Access Compliance Report

Public Rights-of-Way

Intersection ID: 31738	Main Street: LEAF_PLUM_DR	Cross Street: SAWLEAF_CT	Location: SW
ADA ID: D5F7287FE4F1	Ramp Type: PerpDiag	Initial Pass/Fail: Pass	Overall Compliance: No
Severity Score: 12.5			
Codes/Mitigation Info/Possible Solution		Field Measurements/Component Compliance

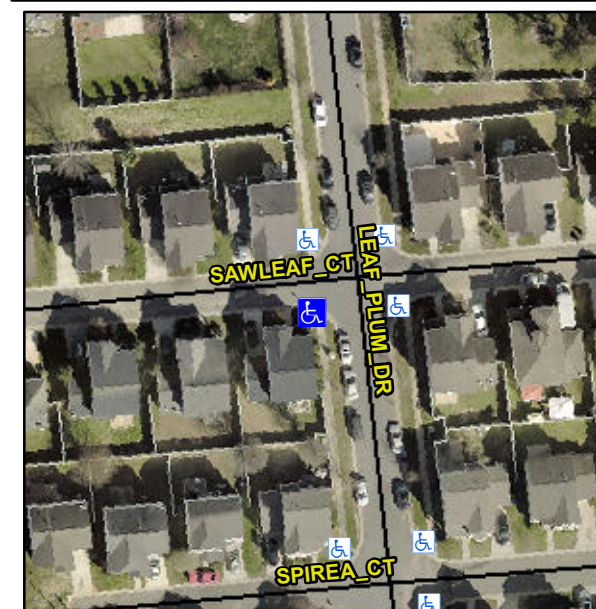
Not Found, R304.2.1, R304.2.2-Perp, R304.3.2-Para, R305.2, R302.7, R302.7.2, R304.5.4

Compliance	Description	Data	Compliance	Description	Data
N/A	Ramp Length (in)	52.0	Yes	Ramp Slope (%)	5.5
Yes	Ramp Width (in)	48.0	Yes	Ramp XSlope (%)	1.3
N/A	Flare Type LT	Sloped	N/A	Flare Type RT	N/A
N/A	Flare Slope LT (%)	5.2	N/A	Flare Slope RT (%)	2.2
N/A	Flare Traversable LT?	No	N/A	Flare Traversable RT?	No
No	Landing Length (in)	38.0	Yes	DWS Provided?	Yes
Yes	Landing Width (in)	49.0	Yes	DWS Contrast?	Yes
No	Landing Slope (%)	2.7	Yes	DWS Length (in)	24.5
Yes	Landing X Slope (%)	1.1	Yes	DWS Full Width?	Yes
N/A	Landing Curb? (Y/N)	No	No	DWS Offset (in)	3.0
N/A	Shared Landing?	Yes			
No	Gutter Ponding?	Yes	No	Gutter Slope (%)	9.5
No	Gutter Lip Ht (in)	0.5	Yes	Gutter X Slope (%)	1.3
N/A	Painted X Walk1?	No	N/A	Painted X Walk2?	No
	X Walk 1 Direction	To E		X Walk 2 Direction	To N
N/A	X Walk 1 Width (in)	N/A	N/A	X Walk 2 Width (in)	N/A
	X Walk 1 Slope (%)	5.1		X Walk 2 Slope (%)	7.8
	X Walk 1 X Slope (%)	3.9		X Walk 2 X Slope (%)	2.4

N/A	Ramp inside XWalk1?	N/A	N/A	Ramp inside XWalk2?	N/A
	Road Slope (%)	1.4	N/A	Clear Space?	Yes
	Road X Slope (%)	5.6	N/A	Clear Space to XWalk (in)	N/A
Yes	Any Obstructions?	No	Yes	Storm Grate/Utility Hazard?	No
	Obstruction Type			Storm Grate/Utility Type	
		N/A			N/A
		Yes		Surface Condition? (G/P)	Good

Remove & Replace Curb Ramp With Two New Directional Ramps or Equivalent. Remove & Replace Gutter.
